SERVICE BULLETIN

No. 63-102

AIR
CONDITIONING
AND
HEATER
ELECTRICAL
CONTROL
CIRCUITS

COMPRESSOR
CLUTCH
FIELD COIL

1963 Plymouth Electrical Control Circuit

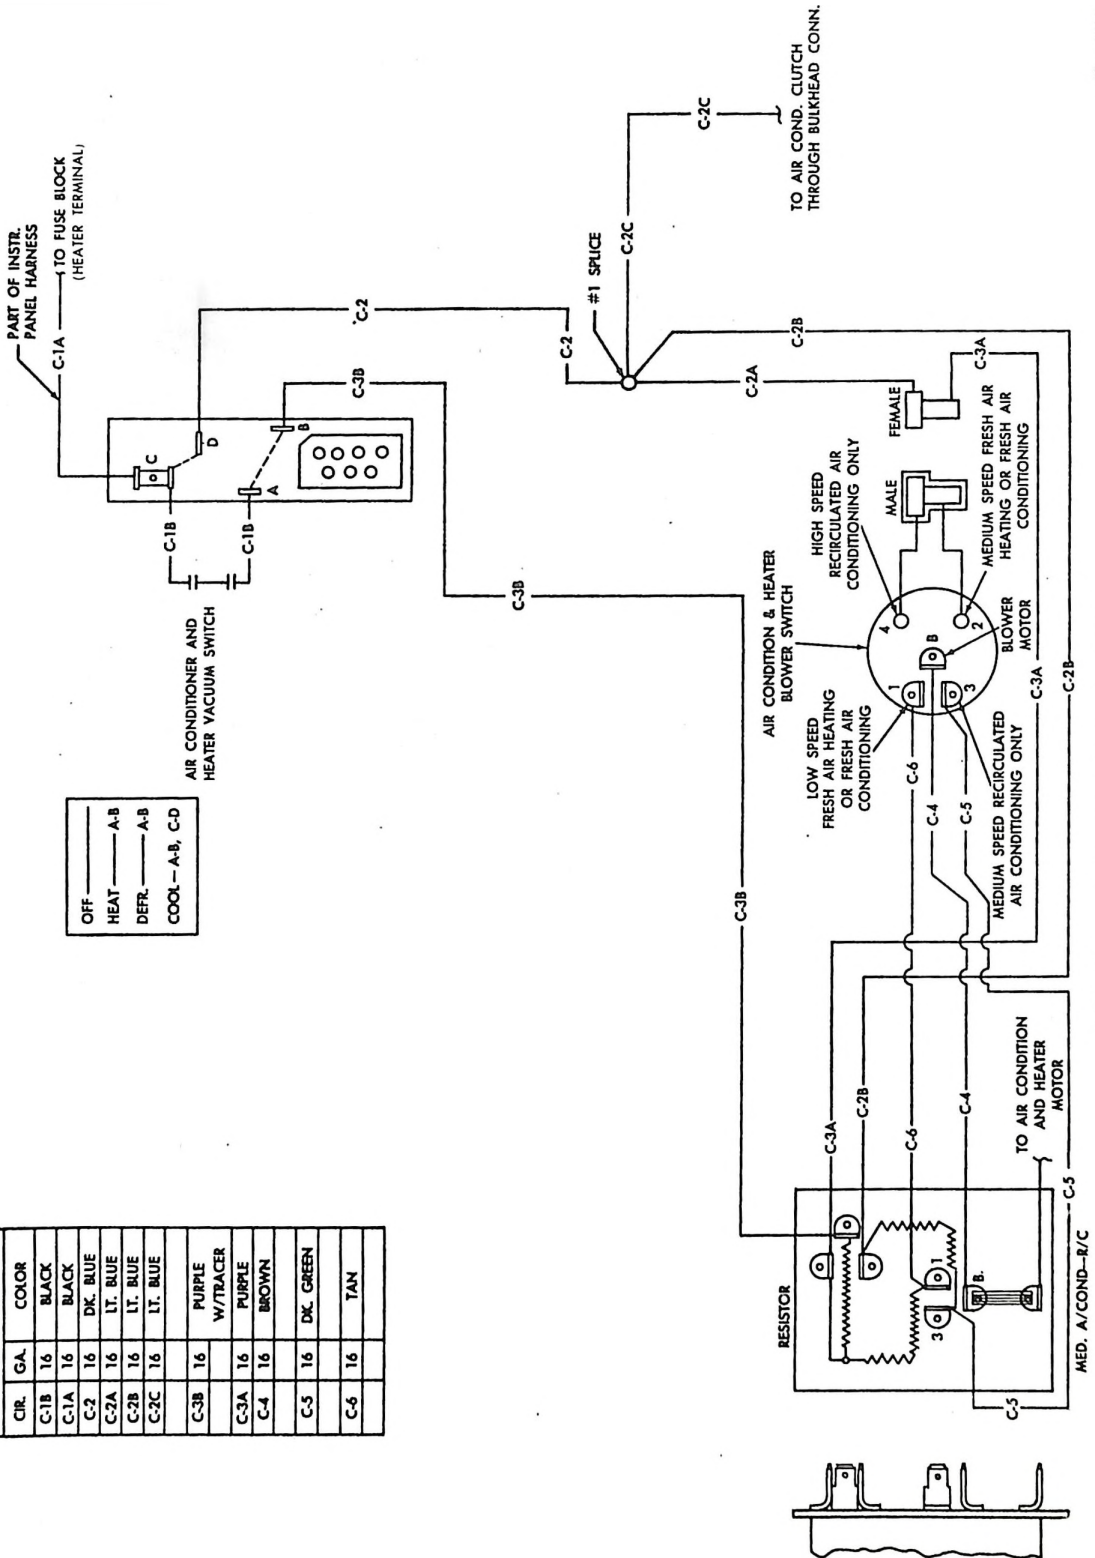
During the later part of November, 1962, improvements to the air conditioning and heater electrical control circuits were incorporated in production. The blower motor relay located on the evaporator housing was eliminated and the control circuits wiring was simplified.

The electrical control circuits wiring diagram shown in Figure 10 on page 24-7 of the 1963 Plymouth-Valiant Service Manual applies to the early production models equipped with a blower motor relay. The attached wiring diagram applies to the late production models which do not have a blower motor relay.

Please insert the attached wiring diagram in your 1963 Plymouth-Valiant Service Manual.

ASSEMBLY - AIR CONDITIONING COMPRESSOR
DRIVE CLUTCH FIELD COIL

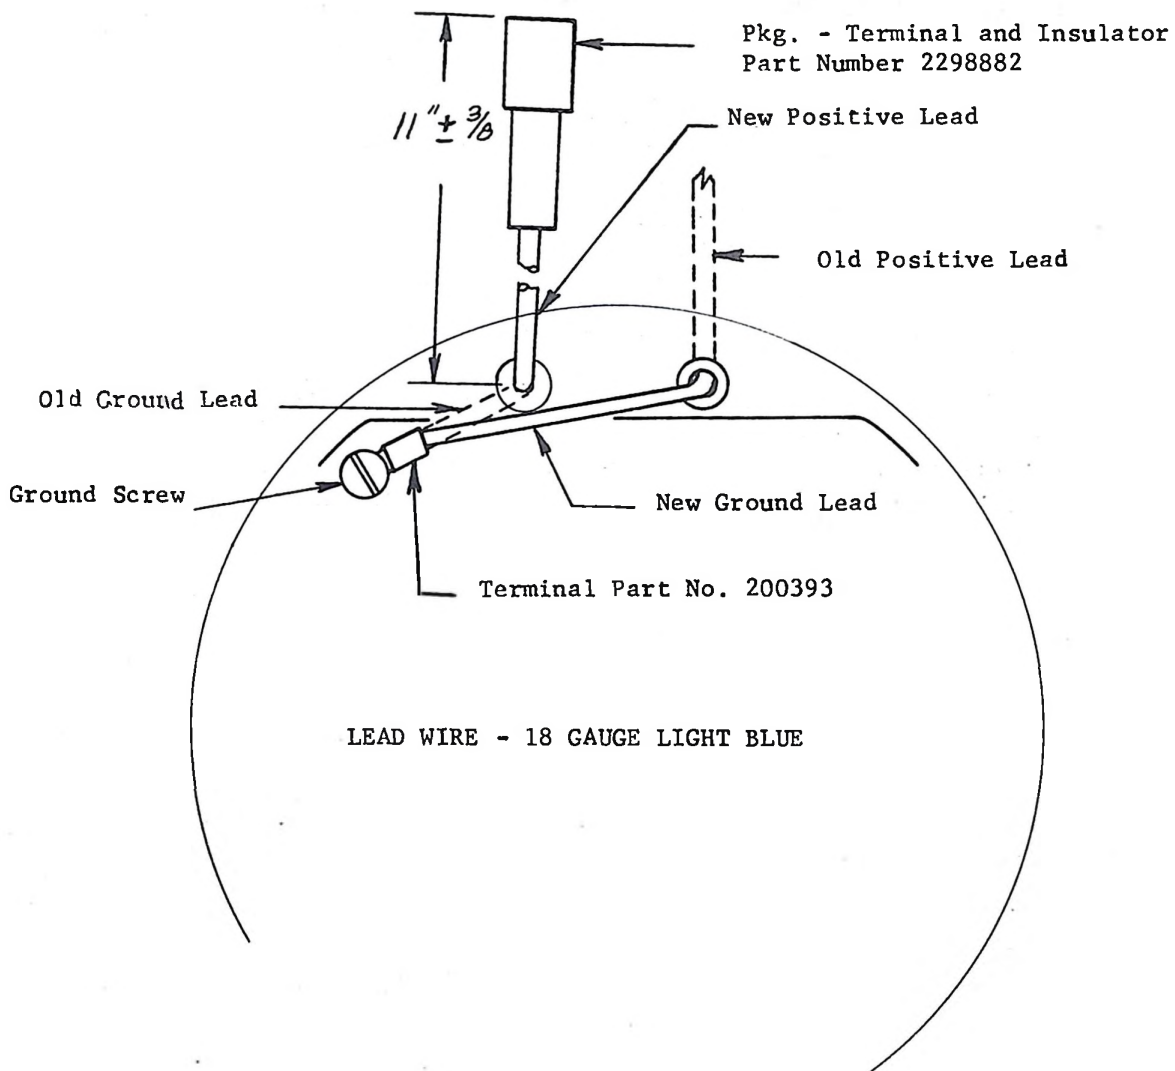
If you encounter a fuse failure on the air conditioning compressor clutch coil circuit, the condition may be the result of the lead wire from the coil winding, grounding on the coil field housing. On 1963 models only, this condition may also result in inoperable electric window lifts, auto pilot and rear window defogger, as they are protected by the same fuse.

If a clutch field circuit fuse failure occurs, the following clutch field coil lead modification should be performed to prevent a fuse failure recurrence.

- (1) Remove the clutch coil from the compressor and place it flat with the wire leads in an upward position. Refer to the illustration on page 2.
- (2) Remove the ground screw from the ground lead and housing.
- (3) Cut the ground lead and splice a piece of No. 18 gauge wire, attach a Terminal and Insulator Package, Part No. 2298882, to the wire, The total length of the wire from the face of the housing, to the end of the insulator should be 11 inches plus or minus 3/8 of an inch. This will now be the new lead wire.
- (4) Cut the original lead wire to 2 inches and attach a terminal Part No. 200393. Attach this new ground lead to the housing with the ground screw previously removed.

FIELD COIL REVERSE GROUND AND POSITIVE LEADS
